OVERLOOK AT HOMESTEAD FILING NO. 1
 EL PASO COUNTY, COLORADO
 CONSTRUCTION DOCUMENTS
 GENERAL NOTES

PRELIMINARY
 FOR REVIEW ONLY
 NOT FOR
 CONSTRUCTION

OVERLOOK AT HOMESTEAD FILING NO. 1
EL PASO COUNTY, COLORADO
CONSTRUCTION DOCUMENTS
POND B1 OVERVIEW

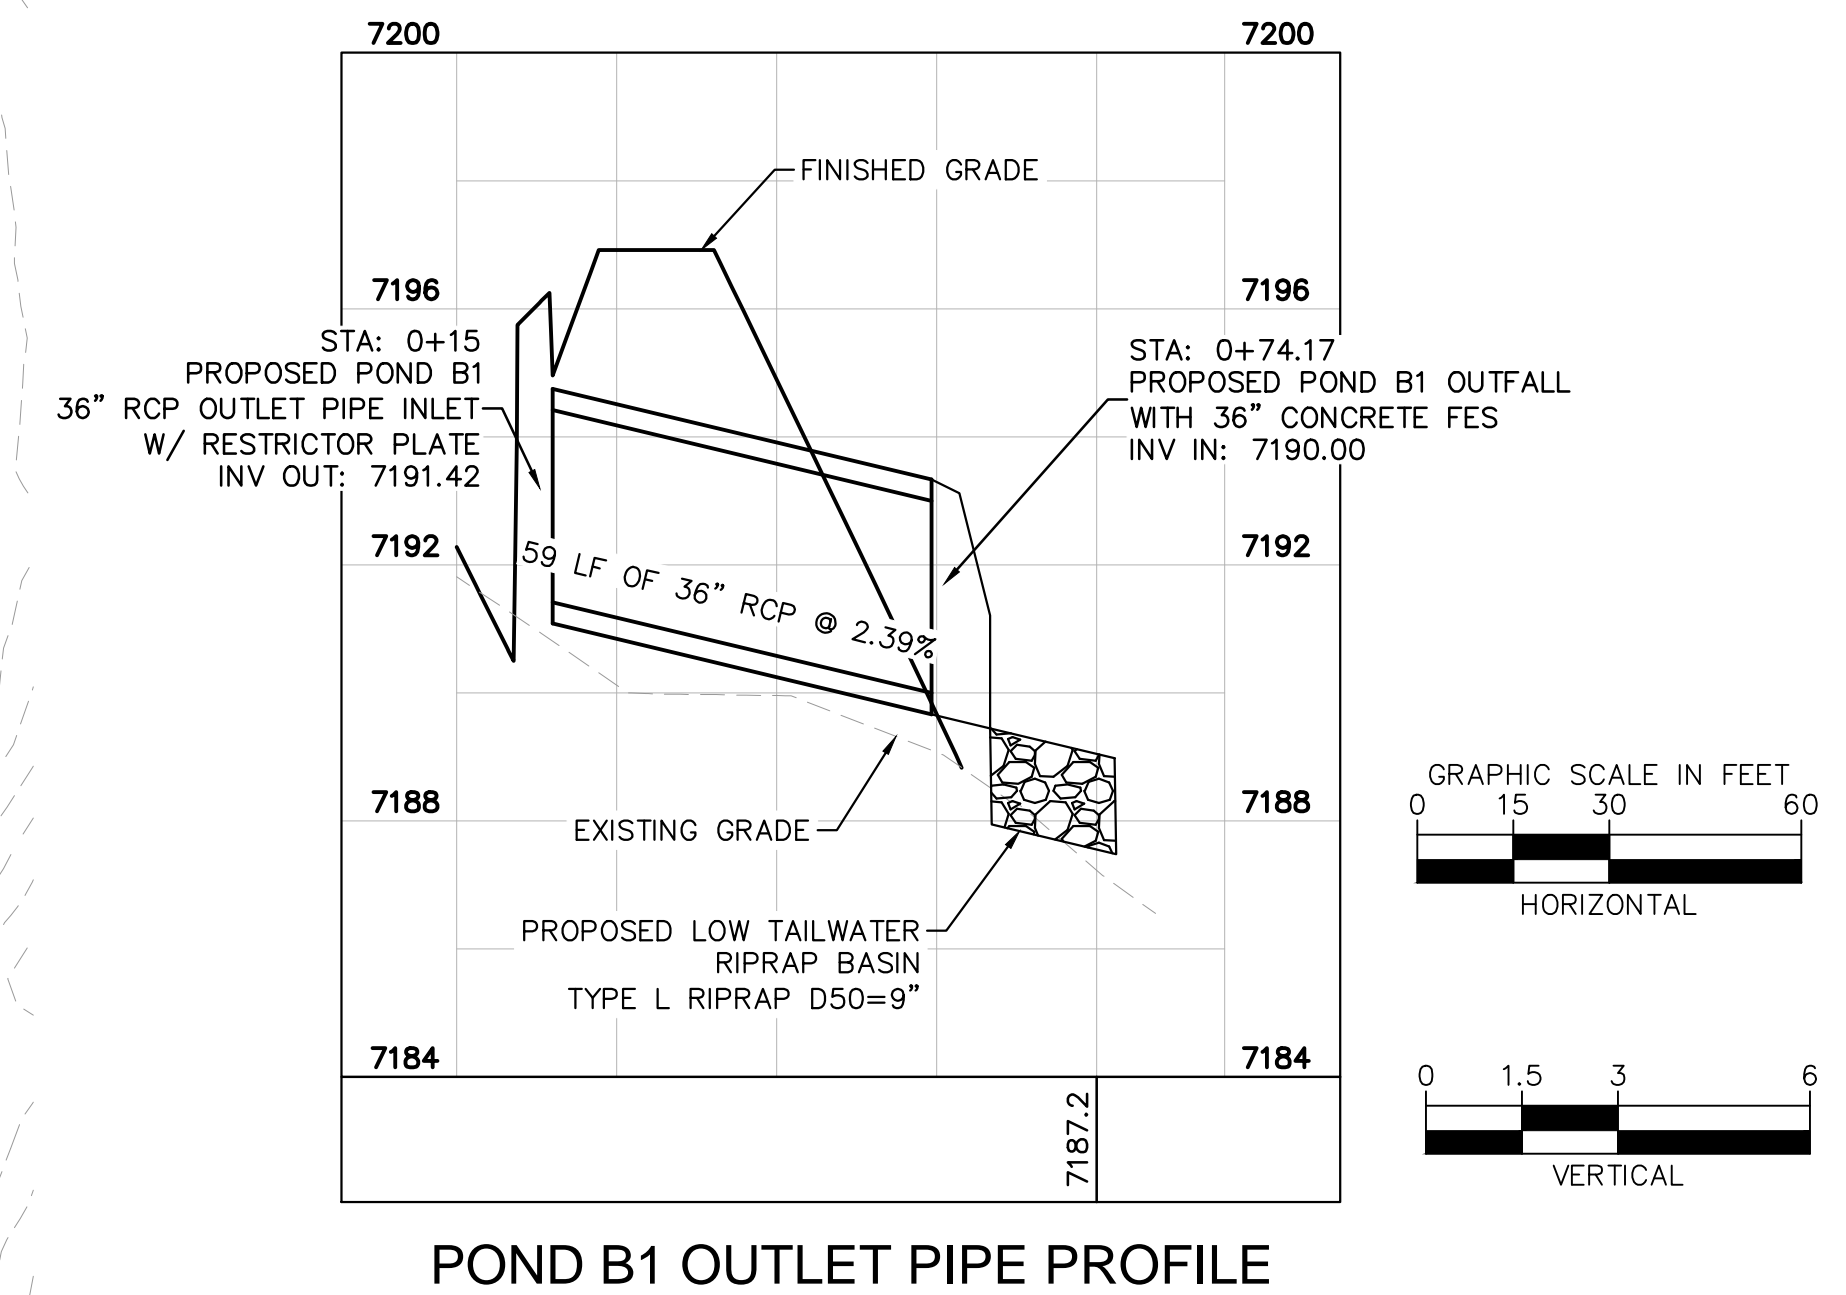
Callout low tailwater basin and reference detail.

10 SECTION CREST WALL DETAIL
1\"/>

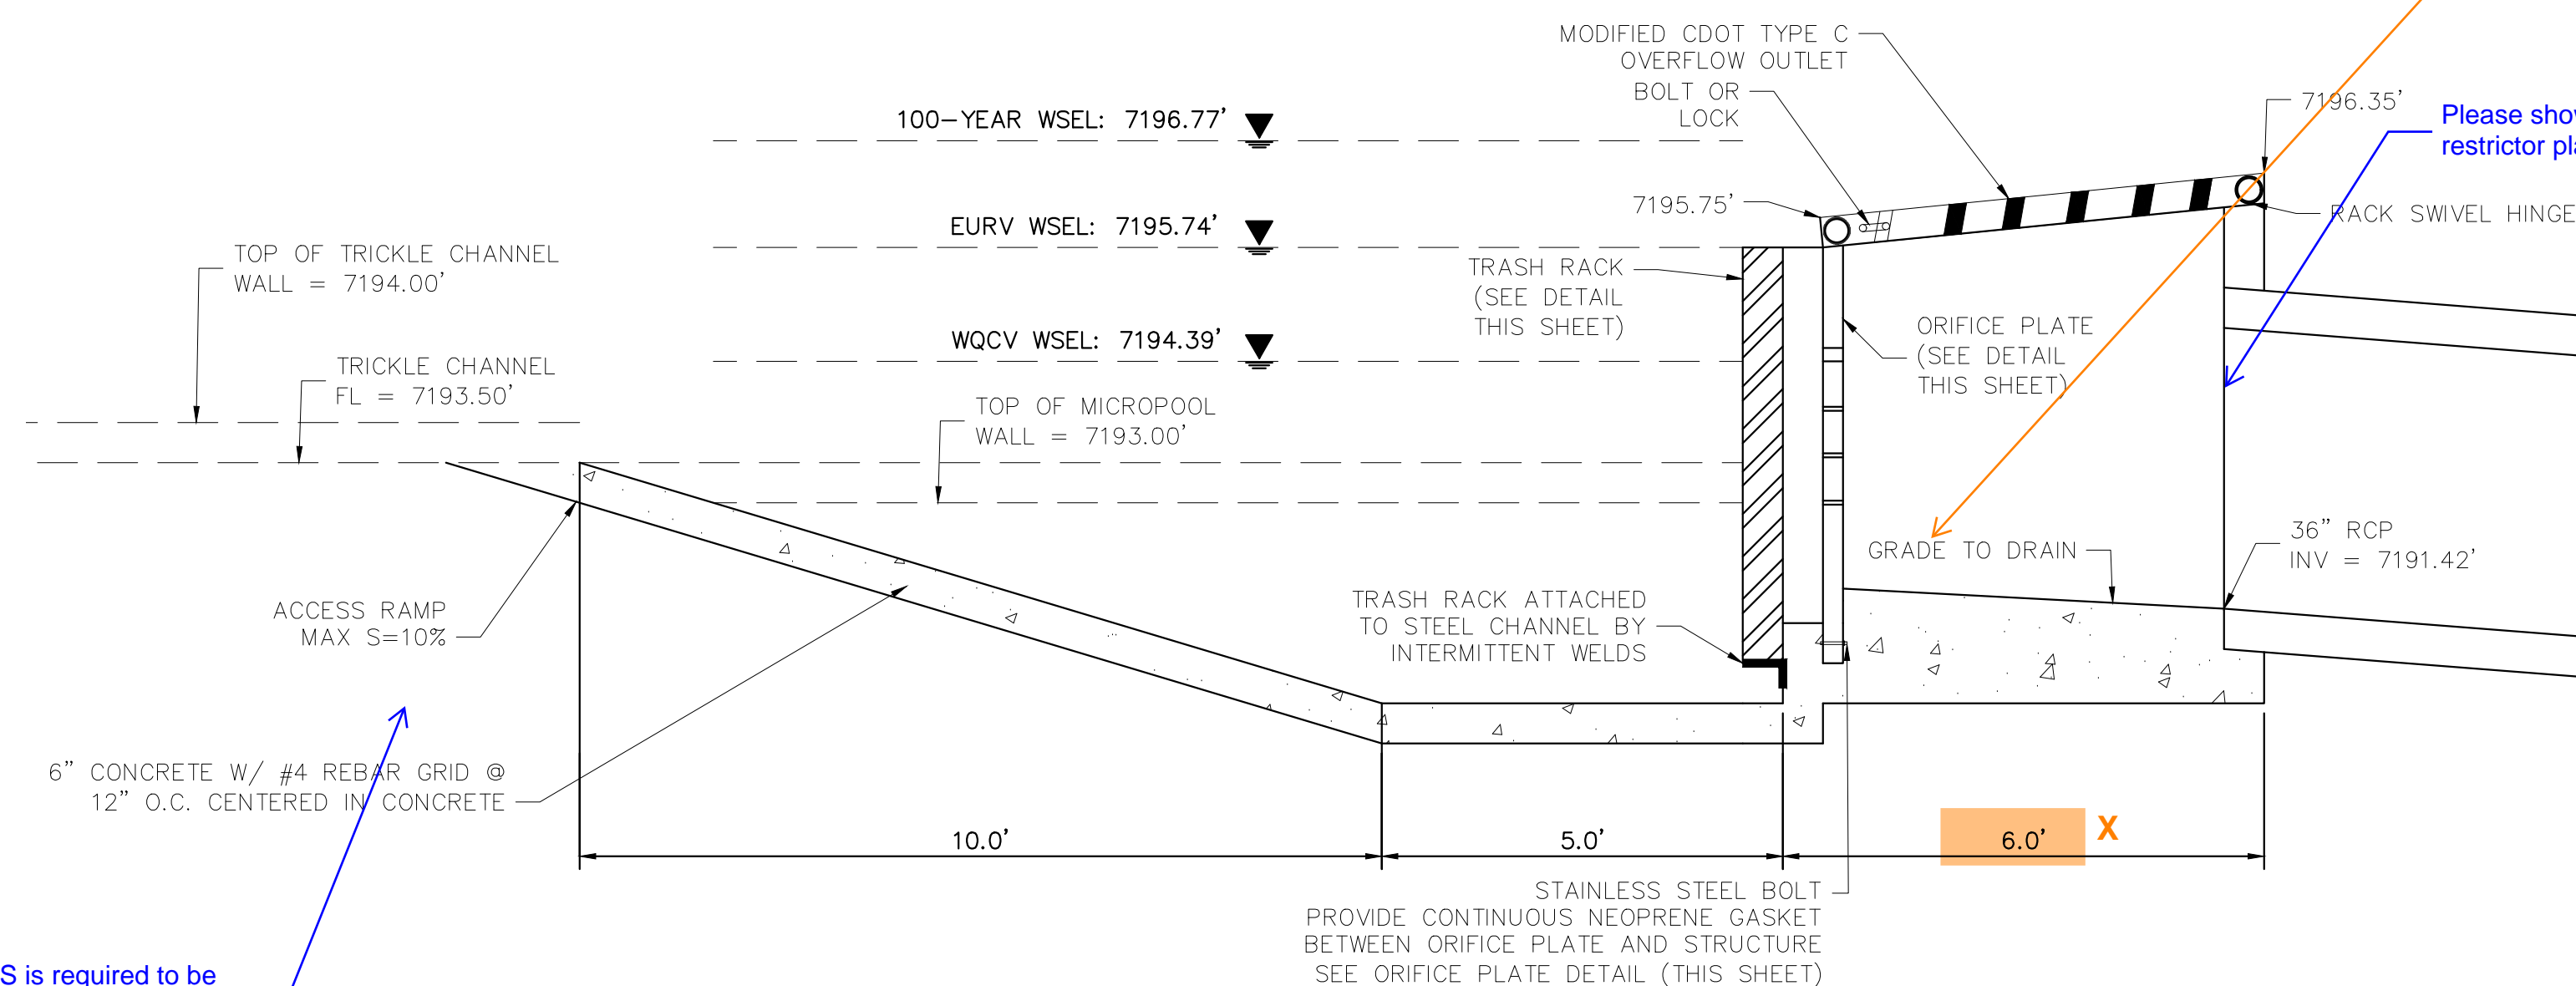
Per USDCM T-12, the outlet structure bottom should have a shaped invert of 2.5% minimum slope (if the invert of the outlet pipe is at the bottom of the outlet structure). And show line for top of micropool walls. A safety rail should be included for vertical drops of 3 feet or more.
